# Access Compliance Report

### (Curb Ramps)

Intersection ID: 14397	Main Street: BROOKHILL_RD	Cross Street: REMOUNT_RD	Location: NE
ADA ID: 52207C007868	Ramp Type: PerpDiag	Initial Pass/Fail: Fail	Overall Compliance: No
Severity Score: 37.5			
Codes/Mitigation Info/Possible Solution		Field Measurements/Component Compliance

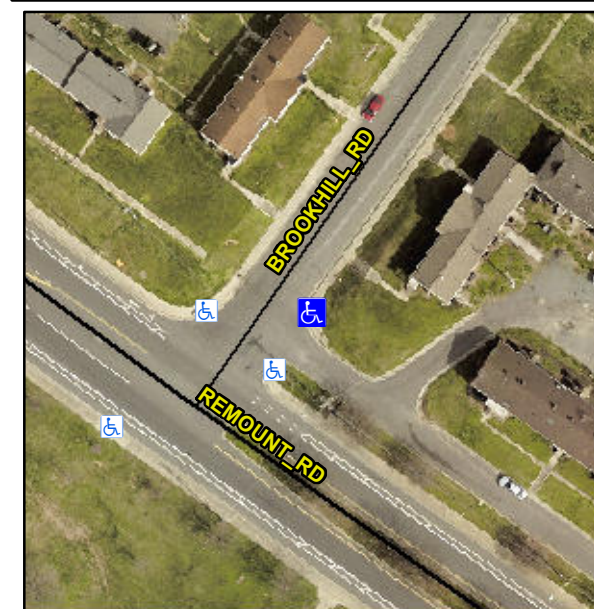
**Not Found, R304.2.2, R304.5.3**

Compliance	Description	Data	Compliance	Description	Data
N/A	Ramp Length (in)	52.0	No	Ramp Slope (%)	11.3
Yes	Ramp Width (in)	48.0	No	Ramp XSlope (%)	8.5
N/A	Flare Type LT	N/A	N/A	Flare Type RT	N/A
N/A	Flare Slope LT (%)	N/A	N/A	Flare Slope RT (%)	N/A
N/A	Flare Traversable LT?	N/A	N/A	Flare Traversable RT?	N/A
N/A	Landing Length (in)	N/A	N/A	DWS Provided?	N/A
N/A	Landing Width (in)	N/A	N/A	DWS Contrast?	N/A
N/A	Landing Slope (%)	N/A	N/A	DWS Length (in)	N/A
N/A	Landing X Slope (%)	N/A	N/A	DWS Full Width?	N/A
N/A	Landing Curb? (Y/N)	N/A	N/A	DWS Offset (in)	N/A
N/A	Shared Landing?	N/A			
N/A	Gutter Ponding?	N/A	N/A	Gutter Slope (%)	N/A
N/A	Gutter Lip Ht (in)	N/A	N/A	Gutter X Slope (%)	N/A
N/A	Painted X Walk1?	No	N/A	Painted X Walk2?	No
	X Walk 1 Direction	To NW		X Walk 2 Direction	To SW
N/A	X Walk 1 Width (in)	N/A	N/A	X Walk 2 Width (in)	N/A
	X Walk 1 Slope (%)	0.9		X Walk 2 Slope (%)	2.8
	X Walk 1 X Slope (%)	4.6		X Walk 2 X Slope (%)	3.1

**Remove & Replace Curb Ramp With Two New Directional Ramps or Equivalent.**
